6 ZON2008-03141

PLANNED UNIT DEVELOPMENT

STAFF REPORT Date: January 22, 2009

DEVELOPMENT NAME Aubrey Hill

SITE PLAN

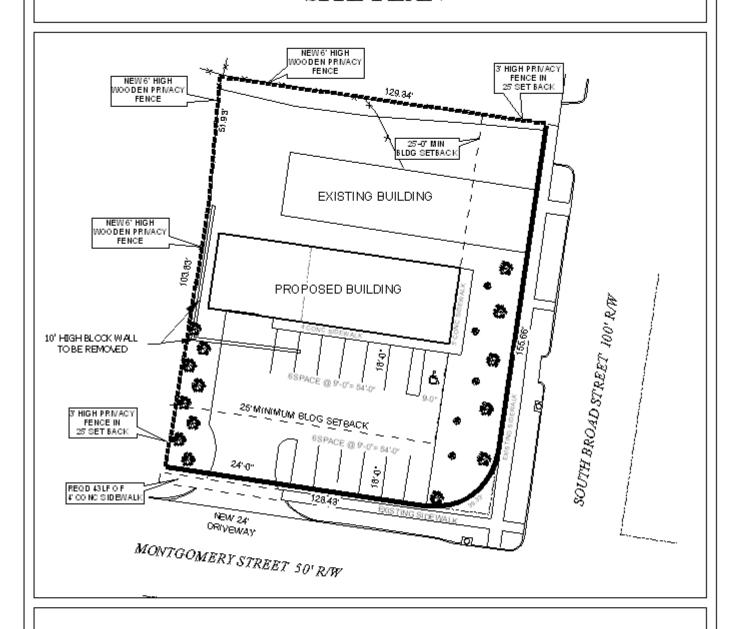
<u>COMMENTS</u> Driveway number, size, location, and design to be approved by Traffic Engineering and conform to AASHTO standards. The two spaces located at the east side of the parking lot do not have adequate space to back out. Changes should be made to the parking layout to accommodate adequate maneuvering space.

There are several issues with the proposed site plan. First, it appears that the proposed building will not meeting the 10-foot setback required by Section 64-4.D.1. of the Zoning Ordinance for where the site abuts adjacent residential zones. Second, the proposed handicap parking space and the space immediately behind it have no area for backing maneuvers, and it also appears that the handicap parking space may not comply with International Building Code requirements (width of space plus width of wheelchair access aisle, as well as location of wheelchair access aisle as it relates to the space). Third, there are no curbs or parking bumpers depicted. Fourth, it appears that there is a dimensional error on the existing building. Fifth, no dumpster is illustrated, and if a dumpster will be provided, it must also meet residential adjacency setbacks and screening requirements. Sixth, the site plan shows a label indicating that the site is zoned R-3, Multi-Family, when in fact it is zoned B-3. And seventh, it appears that the site plan is mislabeled as it relates to the number of parking spaces.

While no site improvements other than a fence are proposed adjacent to the existing building, the existing curb-cut near the existing building appears inadequate to serve commercial uses. Furthermore, access to the rear portion of the existing building will be difficult for trucks in that it appears that maneuvering space will be very limited (and there is no delineation between what

is paved and what is landscape area next to the existing structure). At the same time, tree, landscaping and lighting improvements to the Broad Street right-of-way as part of the "Bring Back Broad Street" initiative may make improvement of the existing curb-cut to today's standards somewhat difficult. However, if either of the two existing curb-cuts onto Broad Street are no longer required, they should be removed as part of the new construction process.

- 1) Redesign of the site to accommodate and depict the required 10-foot residential adjacency buffer, as required by Section 64-4.D.1. of the Zoning Ordinance;

- 2) Revision of the parking area to provide adequate maneuvering area for the last two parking spaces;
- 3) Revision of the parking area to ensure the proposed handicap space meets International Building Code requirements in terms of size and access aisle location;

- 4) Revision of the site plan to depict parking bumpers or curbs so that vehicles will not cross property boundaries or encroach upon sidewalks or required landscape areas;

- 5) Correction of any dimensional errors on the existing building;
- 6) Illustration of a dumpster with proper screening and setbacks, or placement of a note stating how waste will be handled;

- 7) Correction of the zoning label
- 8) Correction of the label regarding the number of parking spaces;
- 9) Revision of the site plan to remove any unnecessary curb-cuts;

- 10) Revision of the site plan to delineate paved and landscaped areas, where they are not shown around the existing building; and
- 11) Placement of a note on the site plan stating that lighting of the site or parking area will comply with Sections 64-4.A.2. and 64-6.A.3.c. of the Zoning Ordinance.
